SPRAB NOTE:

Site Plan
Atlantic Crossing
DeLray Beach
Florida

Drawing No.
SP-2
2 OF 7

SITE PLAN

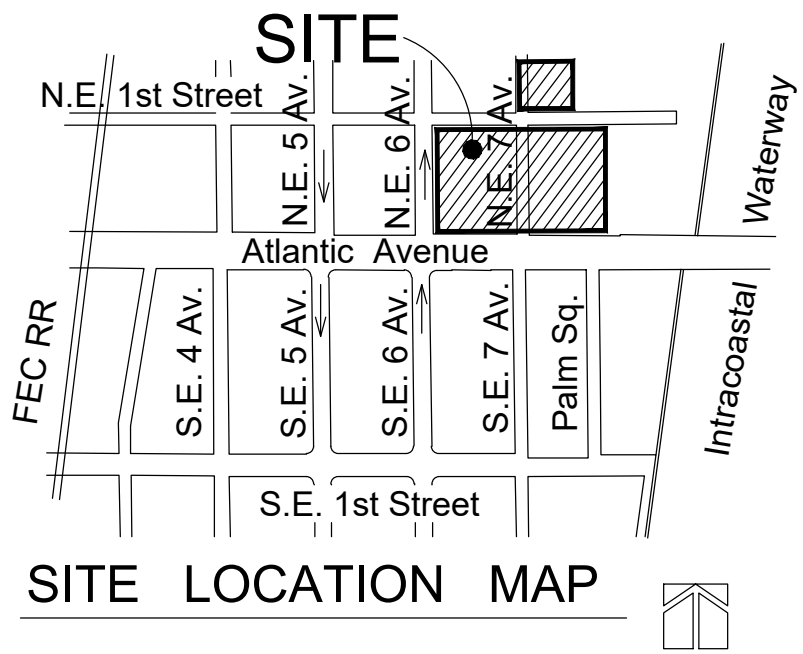
1. OUTDOOR SEATING FOR RESTAURANTS MODESTLY RECONFIGURED TO ENHANCE TENANT OPERATIONS.
2. PLANTERS RECONFIGURED TO IMPROVE PEDESTRIAN CIRCULATION AND ENHANCE RETAIL OPERATIONS.
3. OUTDOOR BAR REDESIGNED TO COMPLEMENT ORGANIC PLANTER FORMS AND RESPOND TO PRIOR CITY COMMENTS.
4. AQUARIUM REMOVED.
5. MINOR ADJUSTMENTS OF PLANTERS AND HARDSCAPE THROUGHOUT TO ADVANCE DOCUMENTATION AND REFLECT BEST PRACTICES.
